BIDDING ADDENDUM # 1

date:	Feb 23, 2022
project:	Tintic High School Track and Field Enhancements
by:	Larry Hepworth
subject:	Addendum #01

A1.A – Sportsfield Specialties Take off board.

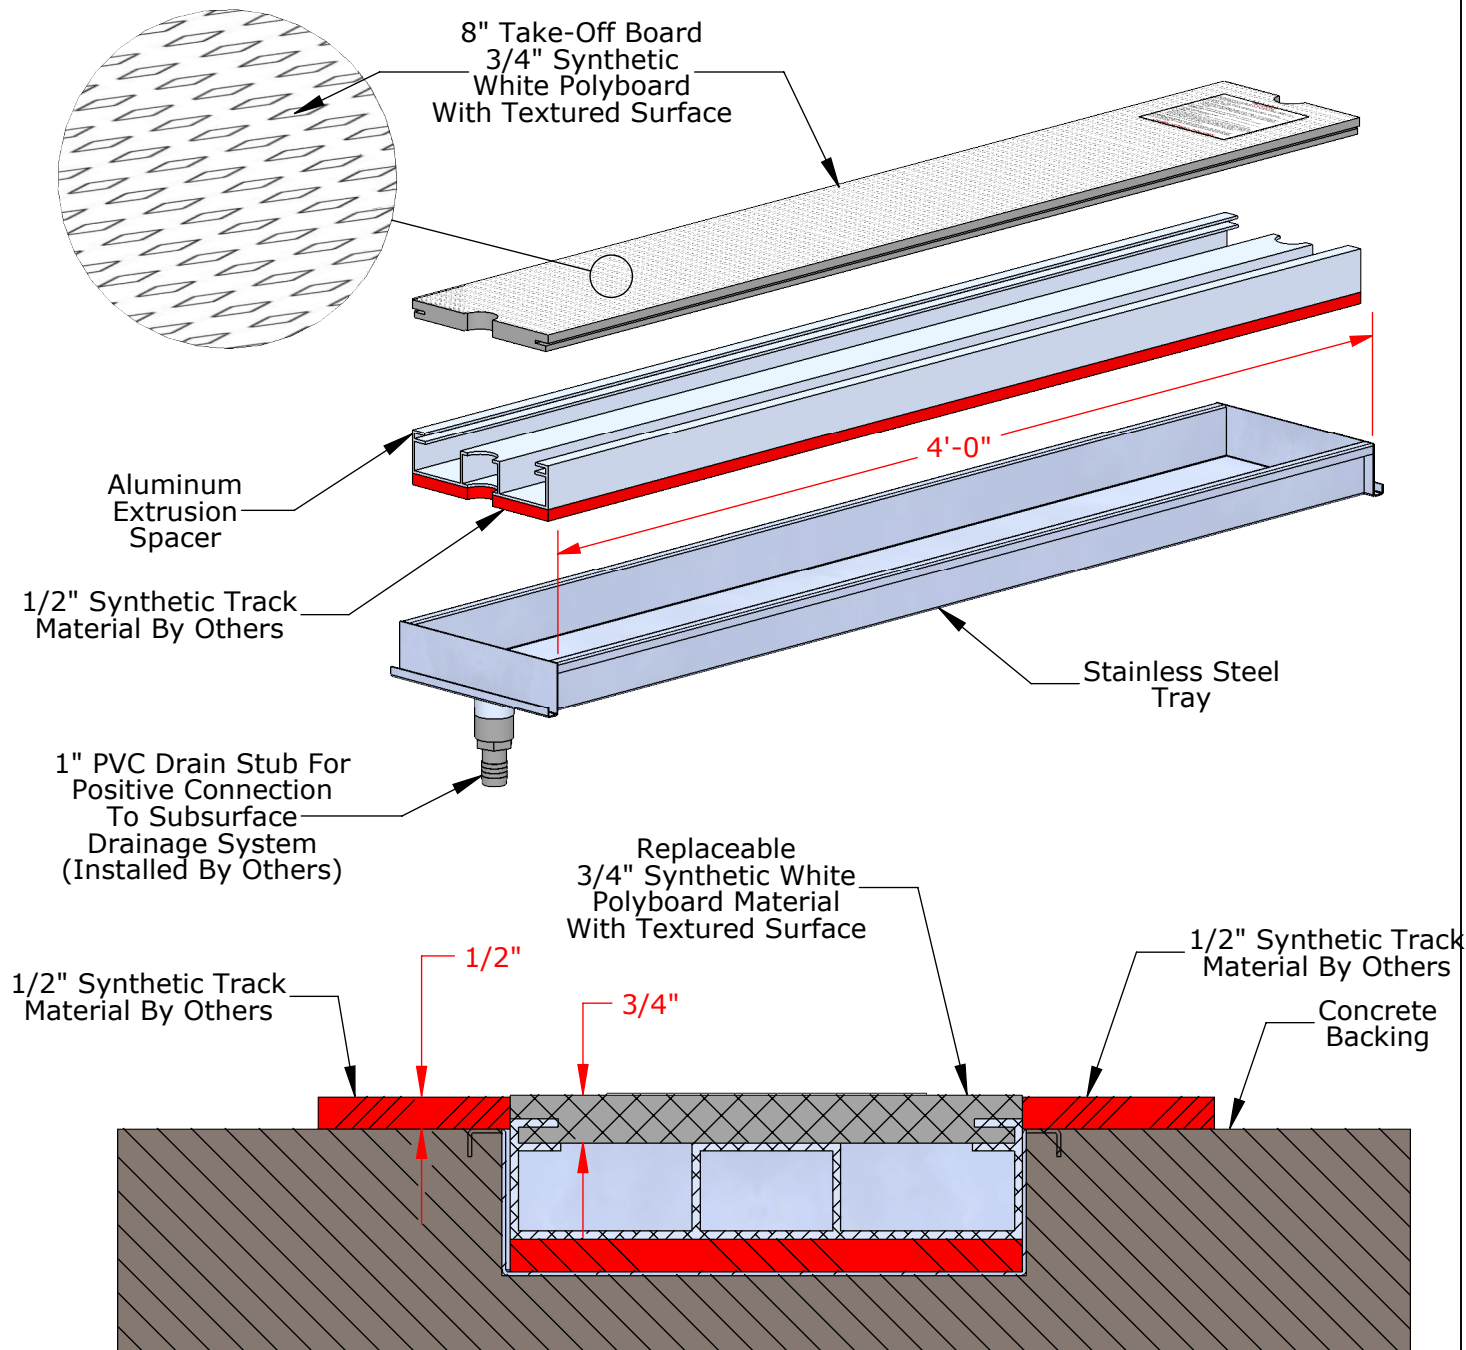
A1.1 – Product Specification- See sheet C-501 Detail 7 key note #2: Long Jump Take off board. – Sportsfield Specialties – LTJTOB8SS-SYN 8” long/triple jump polyboard take-off board system. See attached cut sheet. (Quality to match if substituted.)
